RENESAS TECHNICAL UPDATE

Product Category	MPU & MCU	Document No.	TN-RX*-A106A/E	Rev.	1.00
Title	Corrections to Manual regarding the USB 2.0 Host/Function Module (USBc) in the RX111 Group		Information Category	Technical Notification	
Applicable Product	RX111 Group	Lot No.	Reference Document	RX111 Group User's Manual: Hardware Rev.1.10 (R01UH0365EJ0110)	
		All

This document describes corrections to section 25, USB 2.0 Host/Function Module (USBc) in RX111 Group User's Manual: Hardware.

Figure 25.8 Timing of BRDY Interrupt Generation

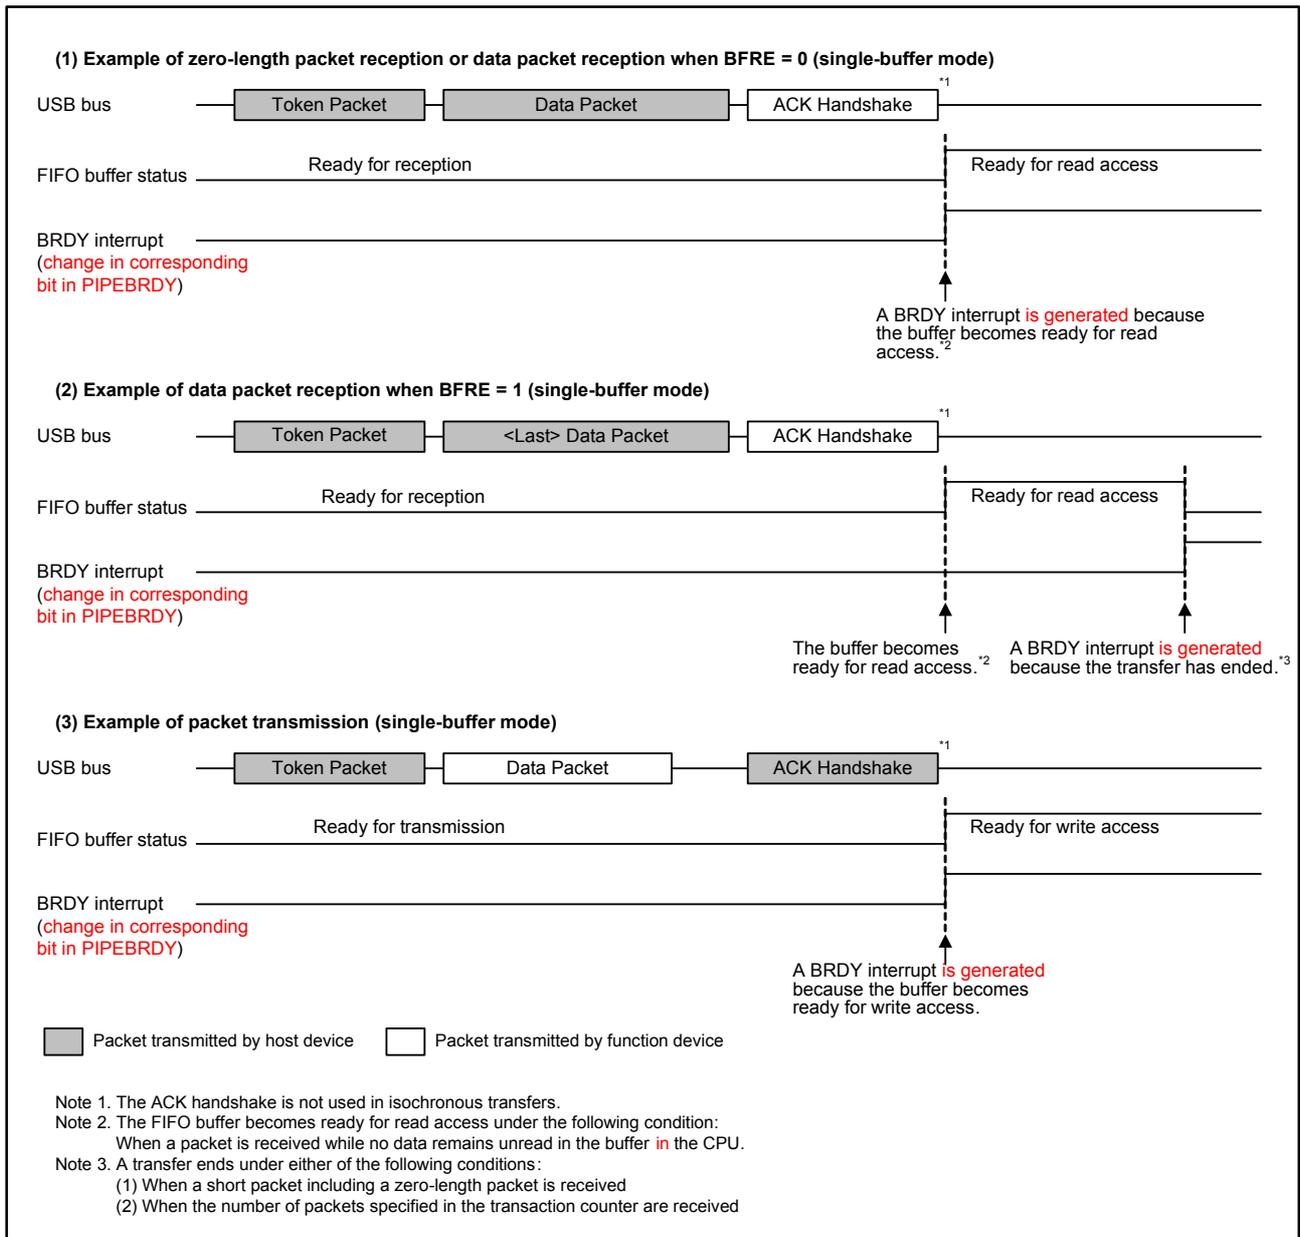
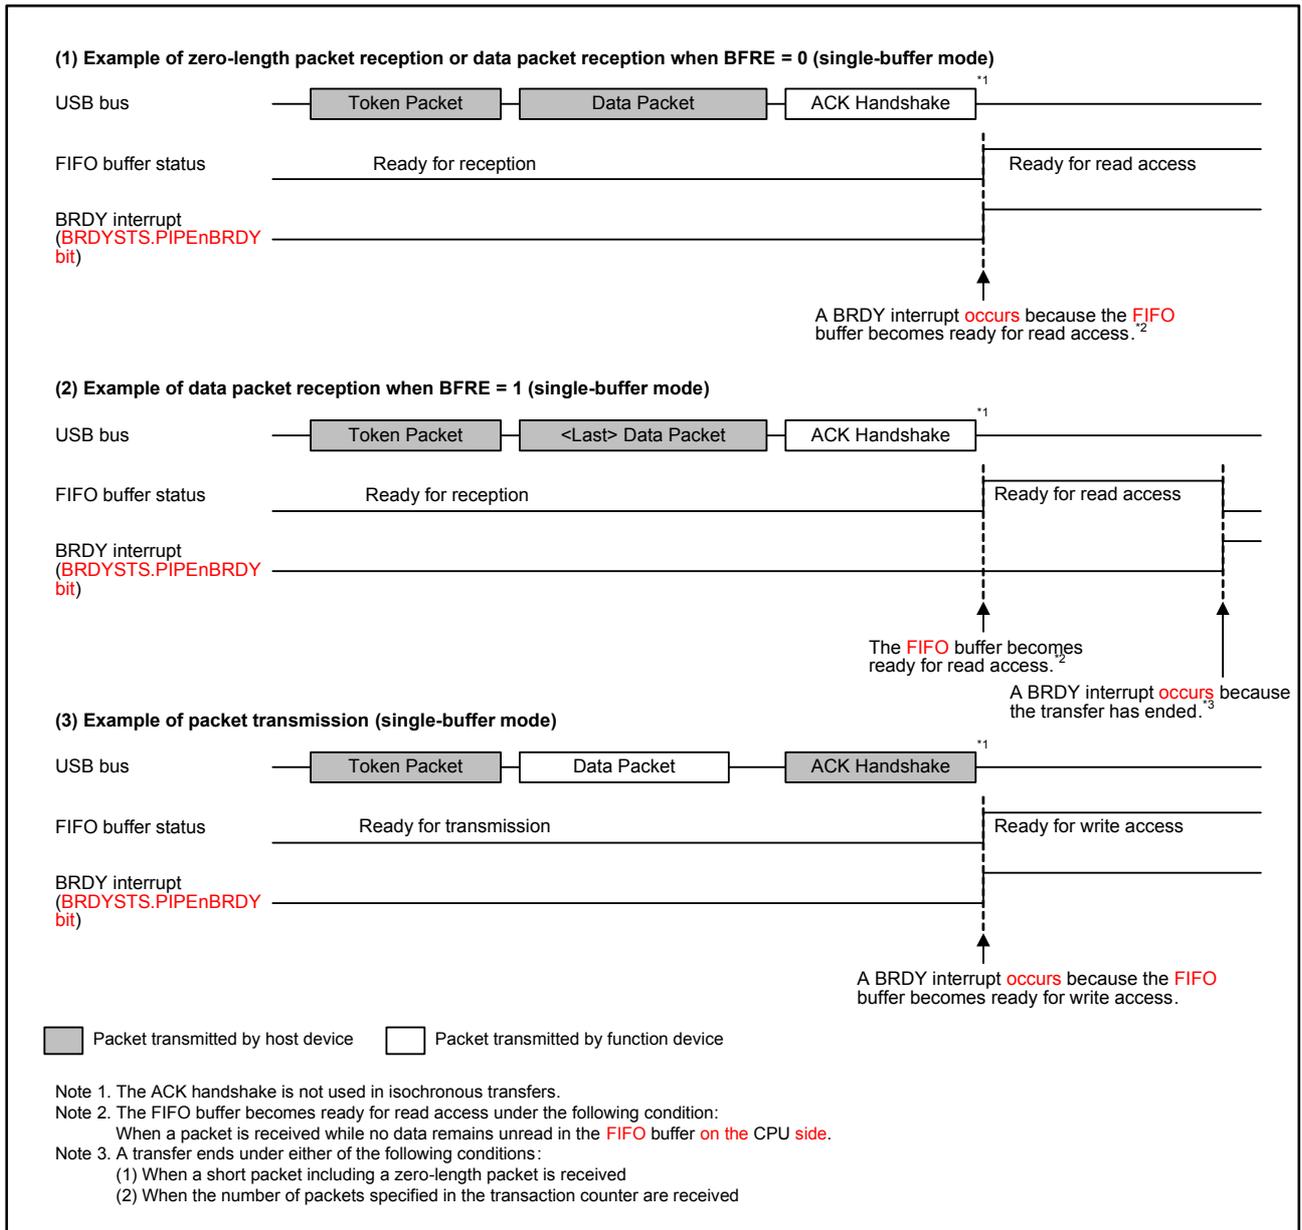
Figure 25.8 is corrected as follows:

Figure 25.9 Timing of NRDY Interrupt Generation (When Function Controller Function is Selected)

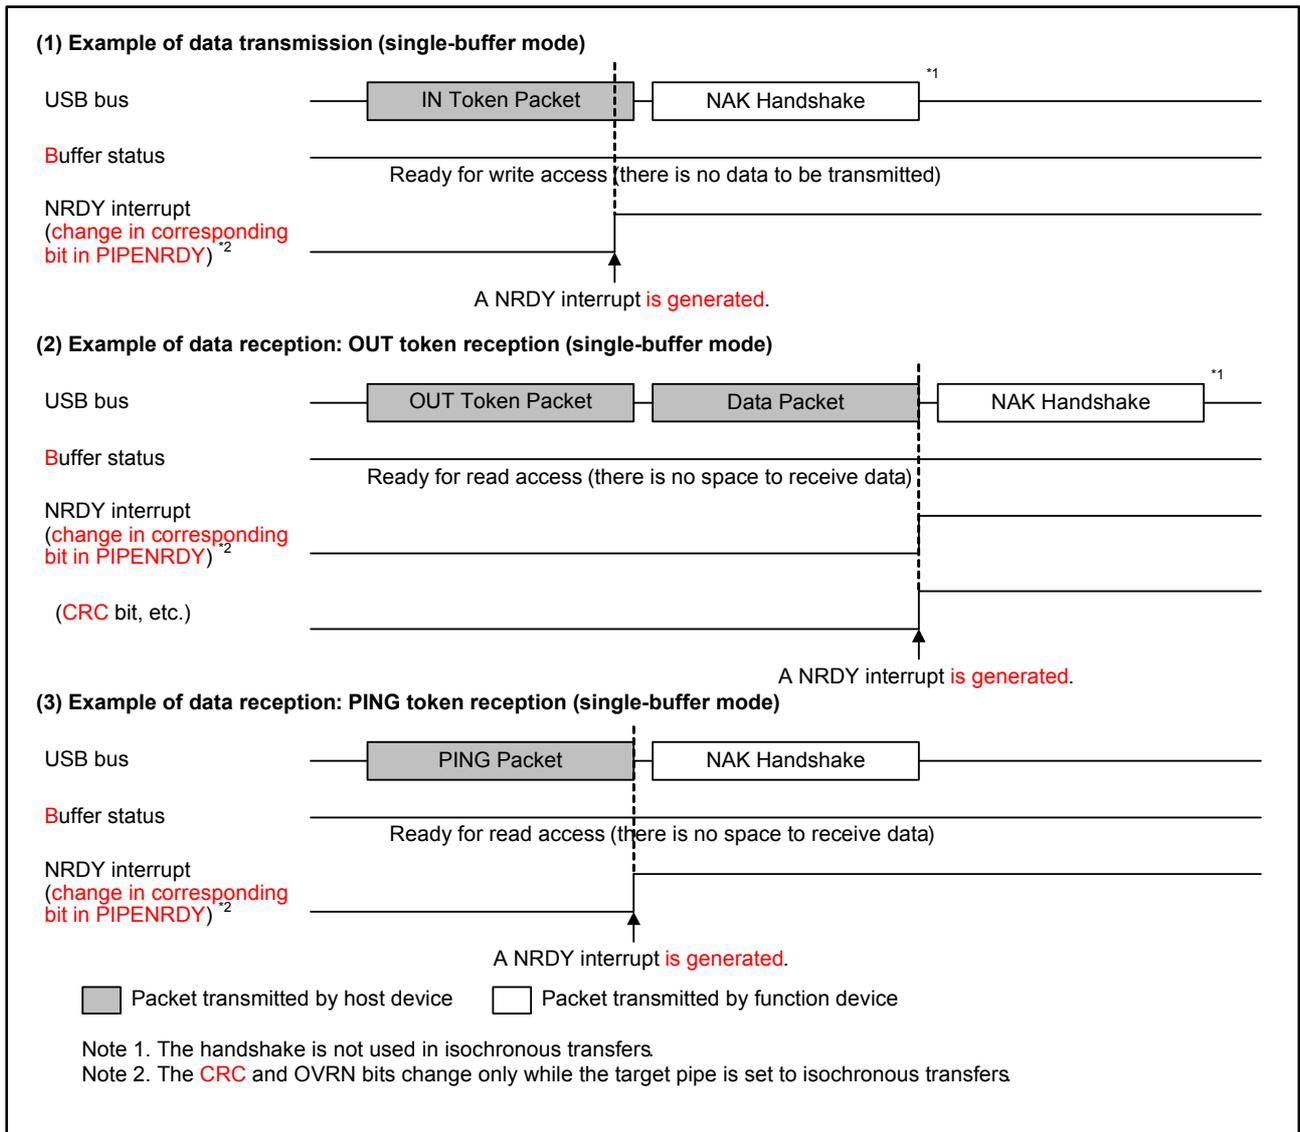
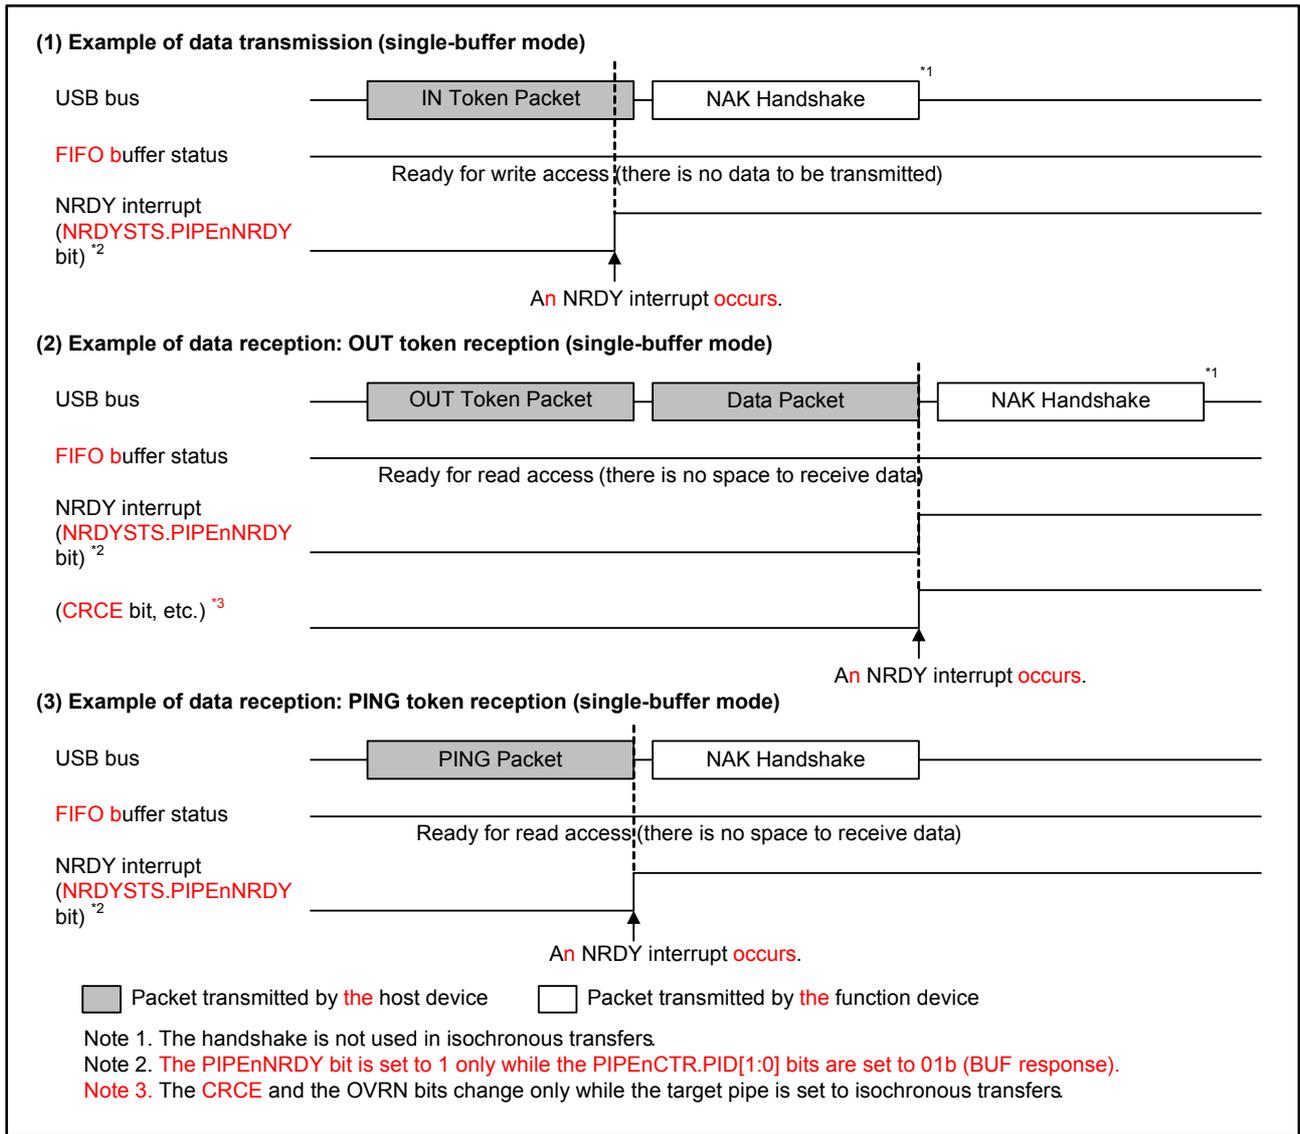
Figure 25.9 is corrected as follows:

Figure 25.10 Timing of BEMP Interrupt Generation (When Function Controller Function is Selected)

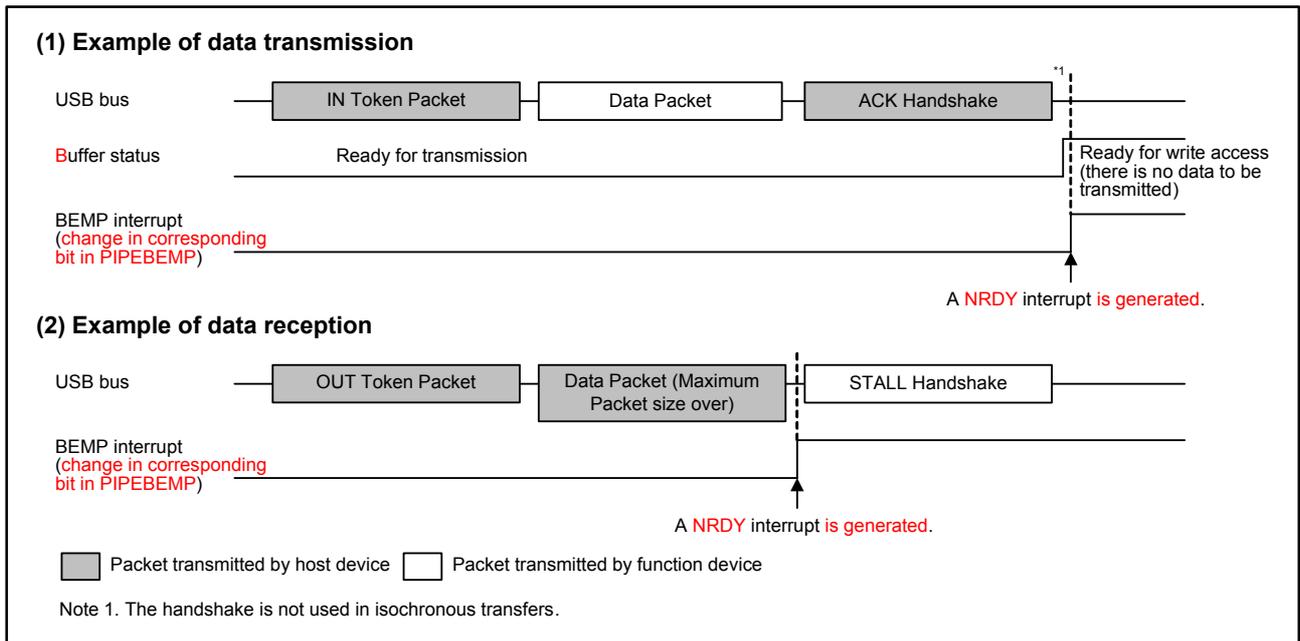
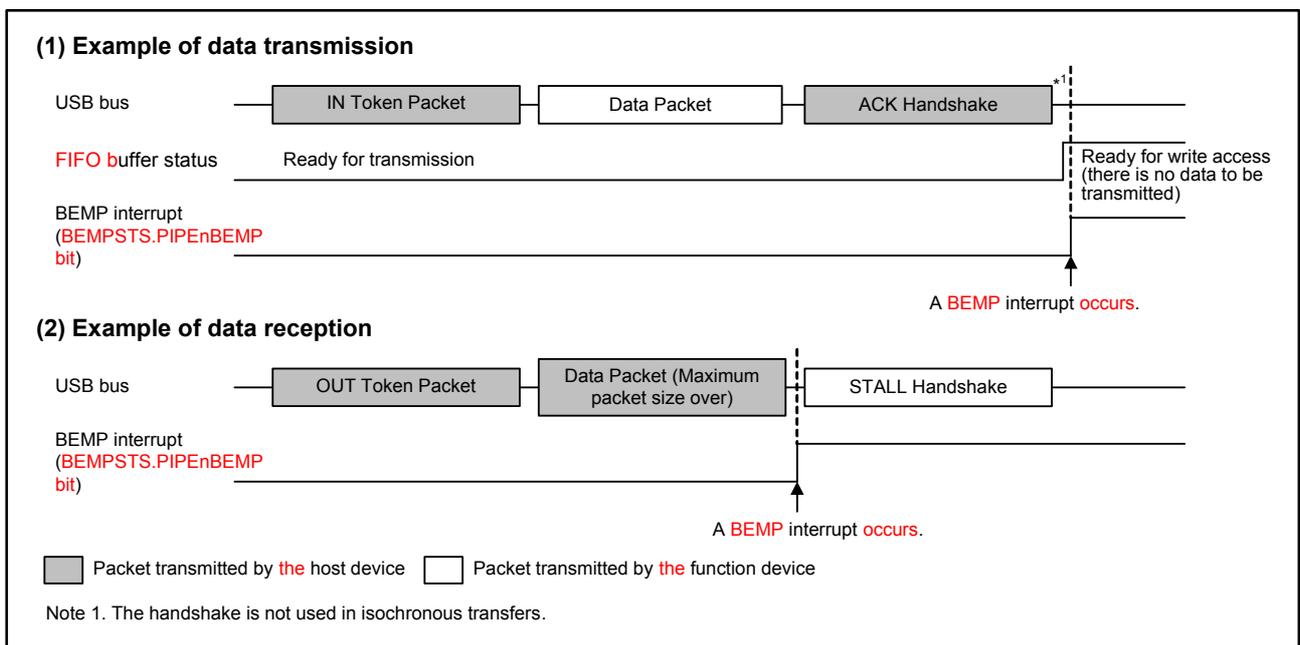
Figure 25.10 is corrected as follows:
